52 NEW STREET - PLANNING BOARD RESPONSE

The below table organizes comments received by the development team for 52 New St following the team's submission of an AHO Design Review package to the Planning Board on September 10, 2021, and presentation to the Planning Board at the public hearing on 10/26/2021. The table is organized into "Comments", identifies the source(s) of the comments, and the right column outlines the design team's response to the comments, with references to graphic figures included as an appendix.

Comments were received from the City of Cambridge Community Development Department memo to the Planning Board dated 10/19/2021, the Department of Public Works memo to the Planning Board dated 10/20/2021, Public comments received in advance of the 10/26/2021 Planning Board hearing and following the team's presentation to the board, Planning Board member comments following the team's presentation, and an Initial Report on the AHO Design Consultation from CDD dated November 12, 2021.

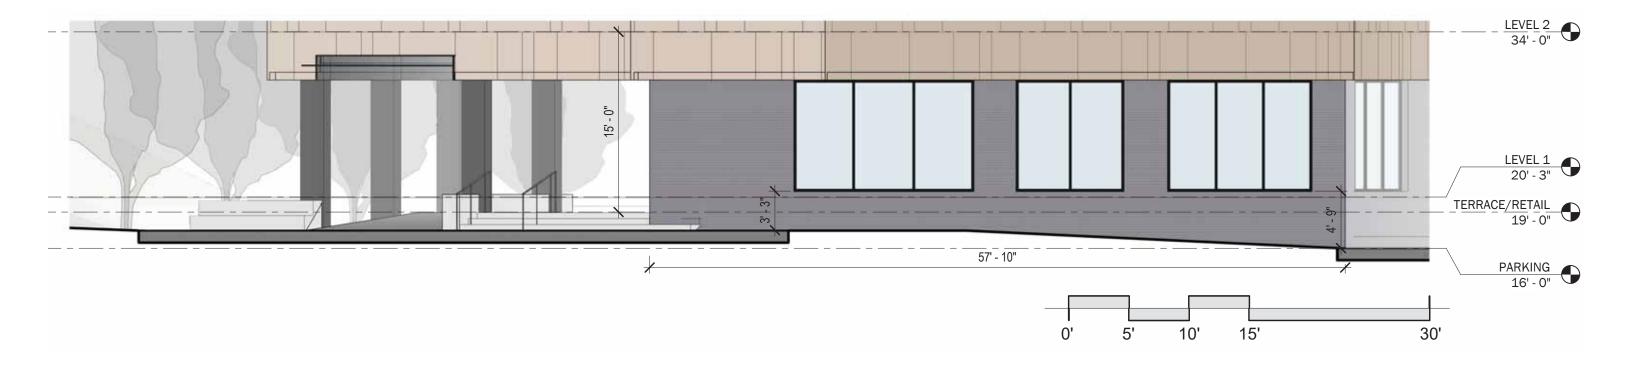
- Break up the parapet on the north elevation to deemphasize the length of the horizontal line
- Provide more variation in the building design on the north elevation to break up the solid wall
- Refine the articulation of the roof line

Shifted proud volumes plan east to shorten the longest facade, giving some of that length to the short volume.

A series of folds introduces a bay rhythm and breaks the long parapet line, with new wood 'reveals' along the facade - breaking down in scale as the facades transition towards Bay State Road.

ground floor screening has been revised to incorporate glazing at the bike room, and a series of landscape screens to break up the long ground floor elevation and further integrate the project with the landscape

MATERIALITY | USE OF COLOR 52 NEW STREET / 12/14/2021 / FIG 24

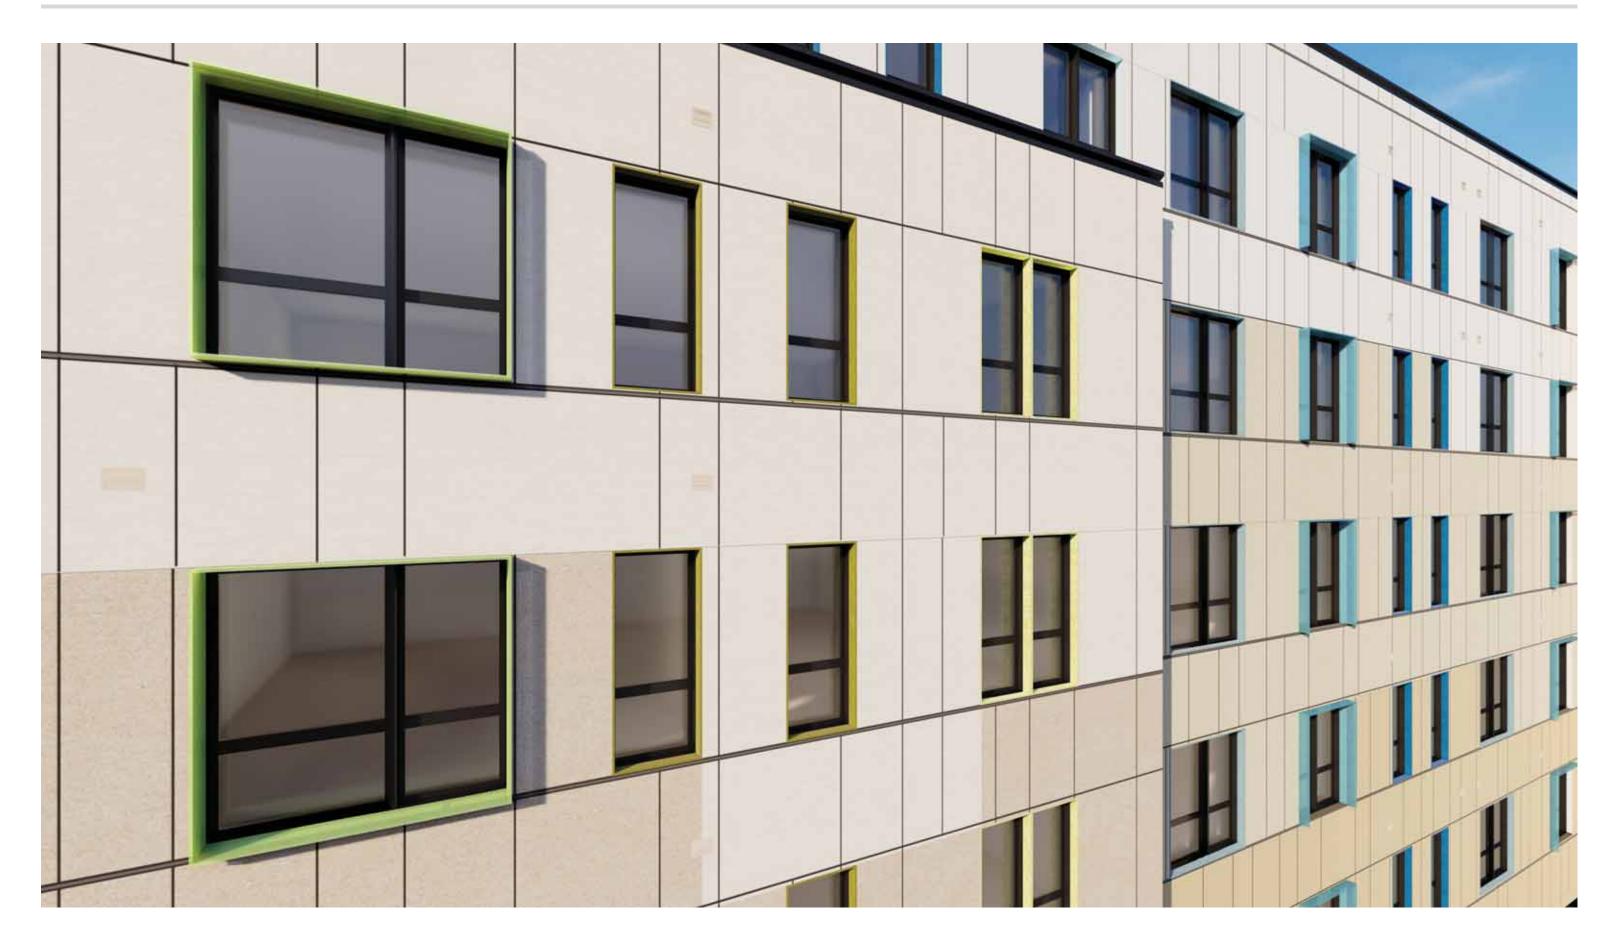
| 52 NEW SIREEL - PLANNING BOAR | 1 | Dec 14, 2021 |
|---|----------------------|--|
| Finds the building drab with very little | PB comment – | panelling. Please see figures 18-19 The earth-tone gradients create a connection |
| variation on the parkside, blends into the | TS, MF, TC, AP | between the building and the lush natural |
| background | / Public | landscape in which it is sited - and avoid the |

| 52 NEW SIREEL - PLANNING BOAR | 1 | Dec 14, 2021 |
|---|----------------------|--|
| | | The project is incorporating color through a |
| | | number of tools, applied with a consistent set |
| | | of rules across the facade. Jamb returns at the deep window recesses, projecting solar |
| | | shading devices, and additional painted metal |
| | | elements work in concert to create a colorful |
| | | play across the facades. |
| | | Please see figures 21-28 for design |
| | | improvements related to facade materiality, |
| | | color, and fenestration. |

VIEW FROM ACROSS NEW STREET / 12/14/2021 / FIG 29

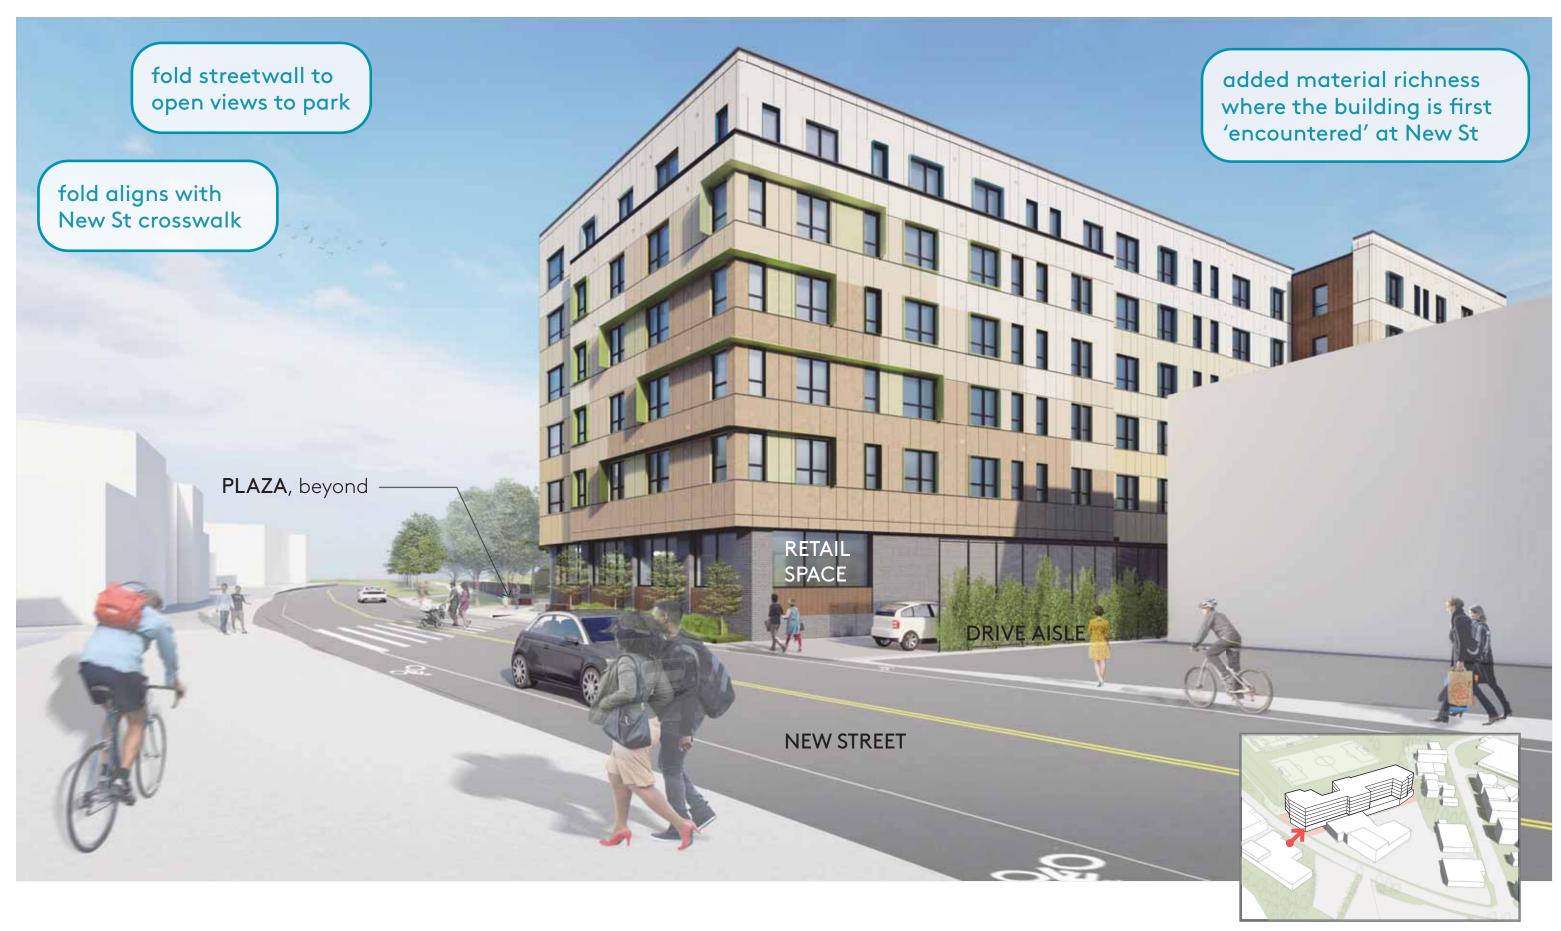
COMMENTS FROM THE BOARD: MATERIALITY

Many Board members were disappointed with the proposed building materials, which they called "drab." Board members disagreed on the appropriateness of the wood veneer, but most would like to see a bolder and more playful color scheme.

Increase the size and span of the solar shades on the New Street corner. These louvers will be painted in bold shades. Additionally, the folded volume over the retail entry has been modified to be a green tone to mark the significance of the entry.
